#### **Land Use Application**

RECEIVED 01/21/2025 CITY OF BELLINGHAM PERMIT CENTER BLD2025-0047 2404 H ST

ADU2025-0006

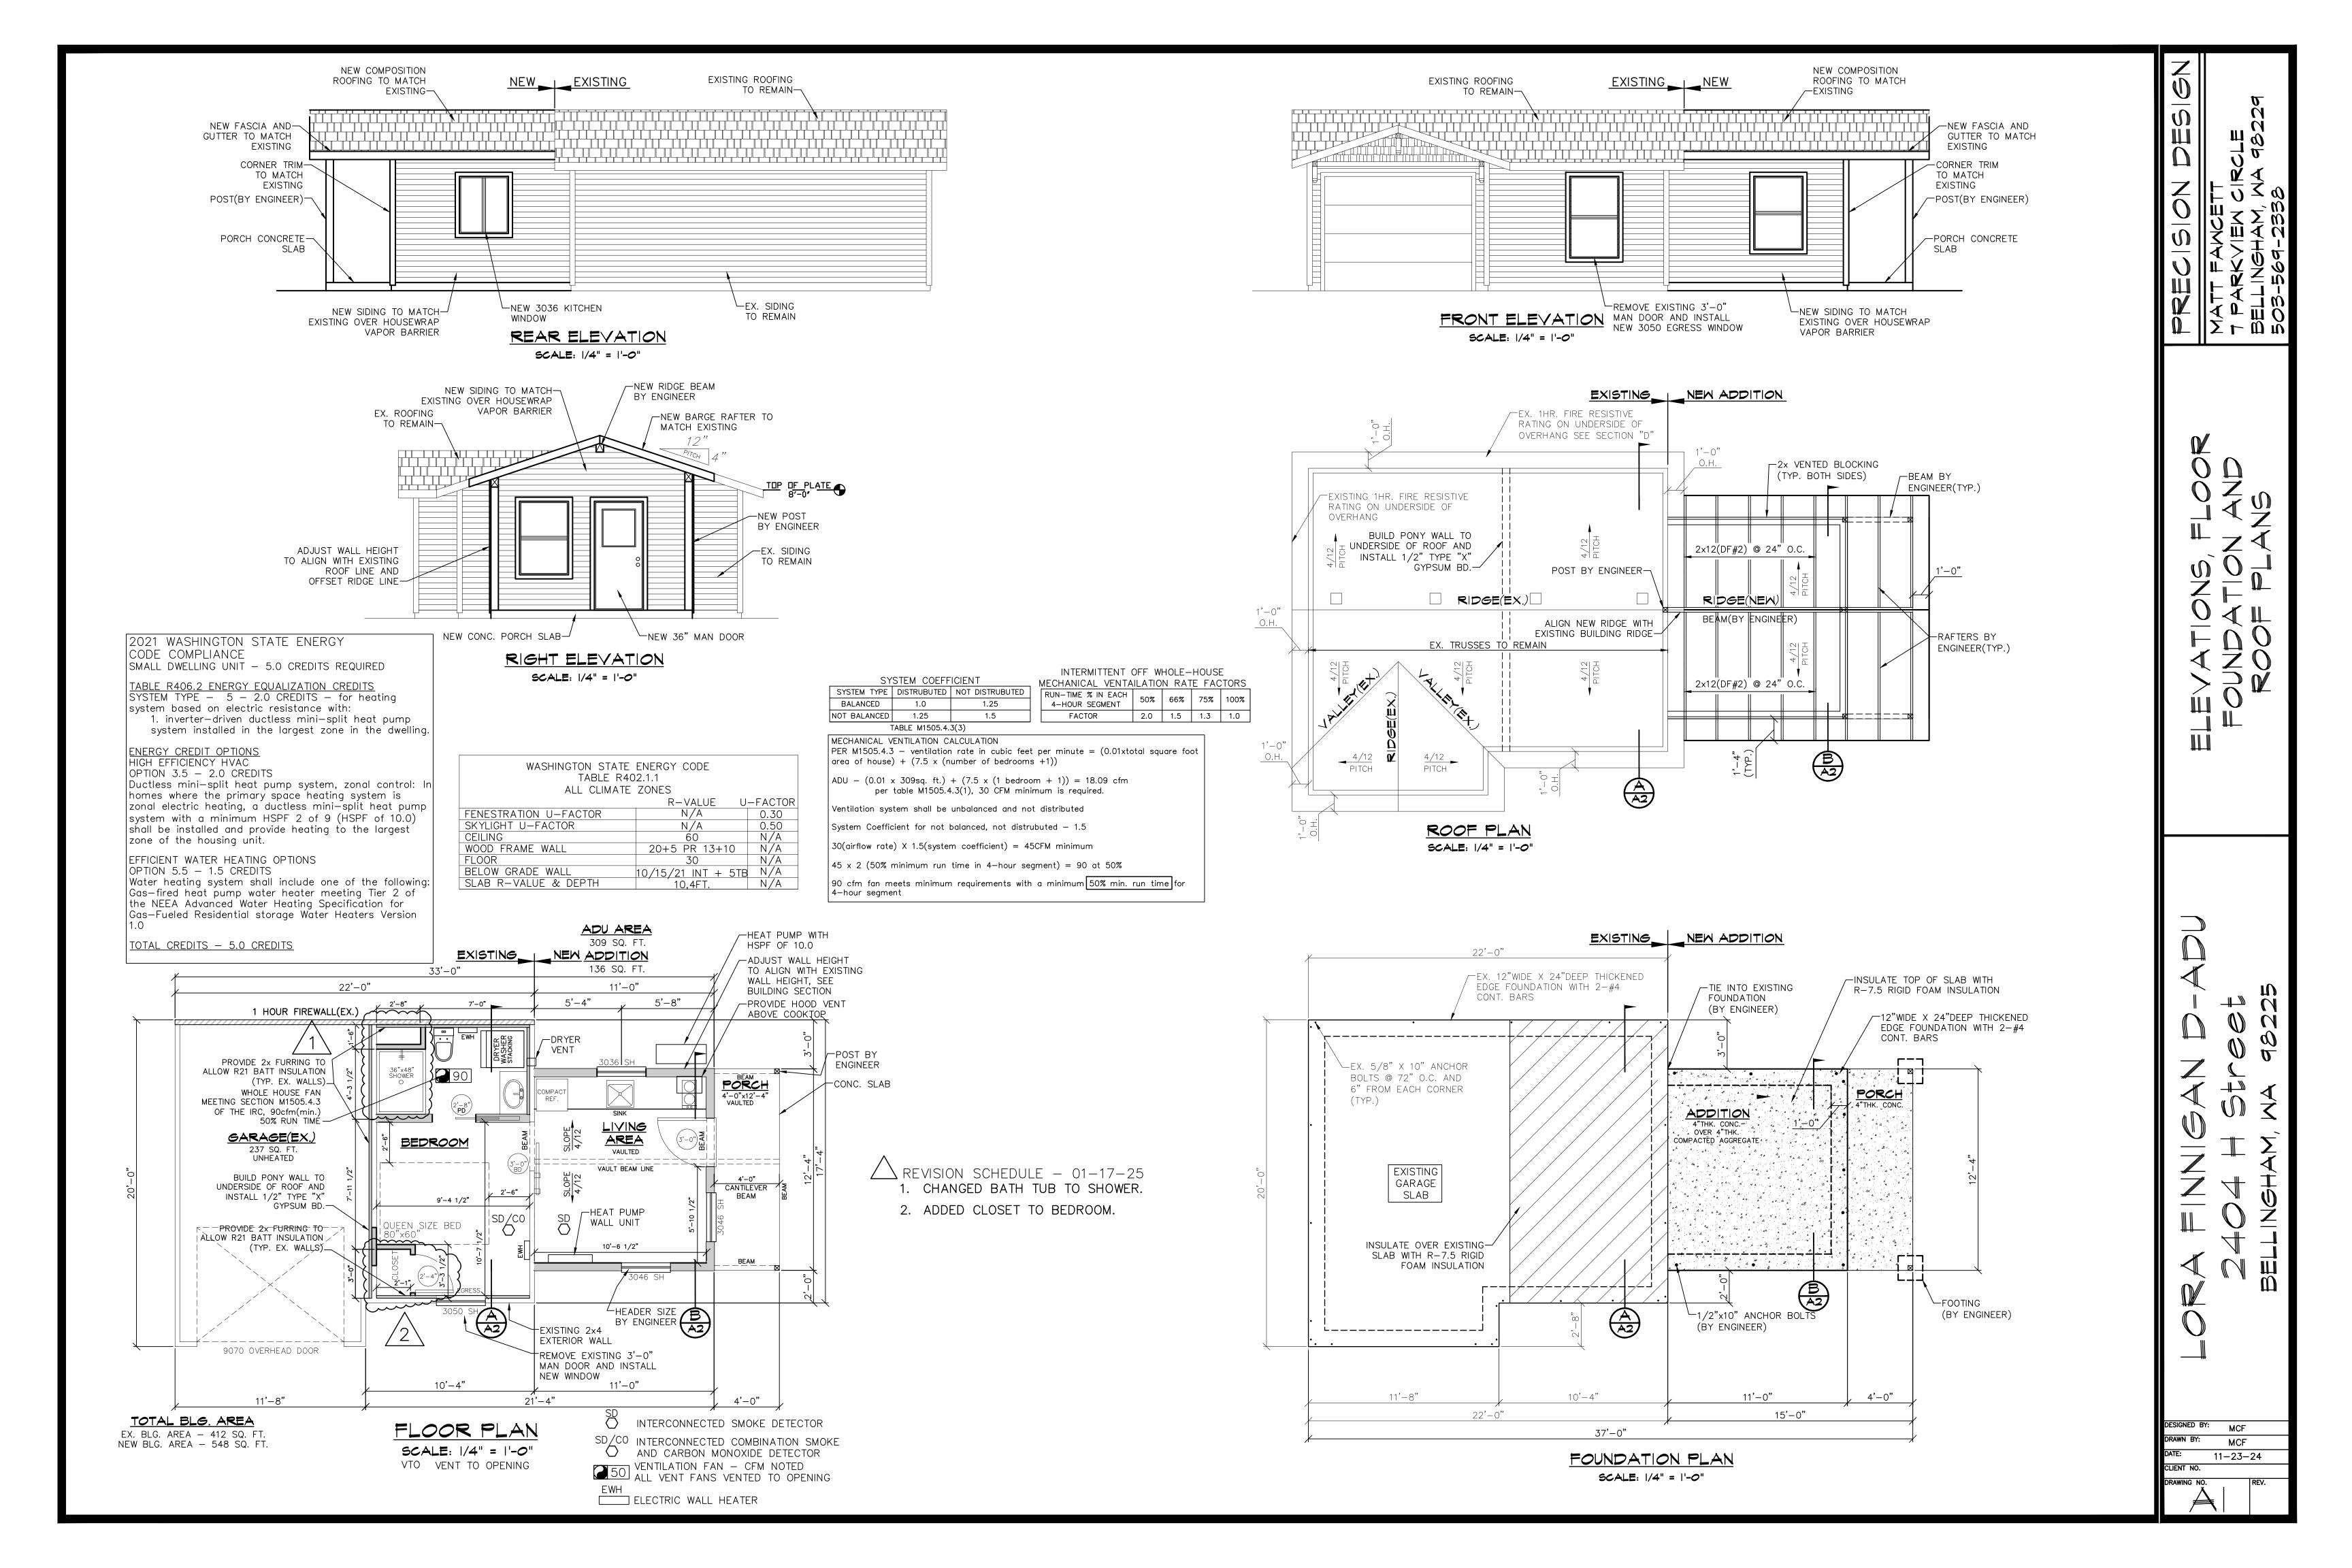
The site plans indicate impervious area will exceed the maximum listed in 16.80.090. The site plan does not make any stormwater improvements.
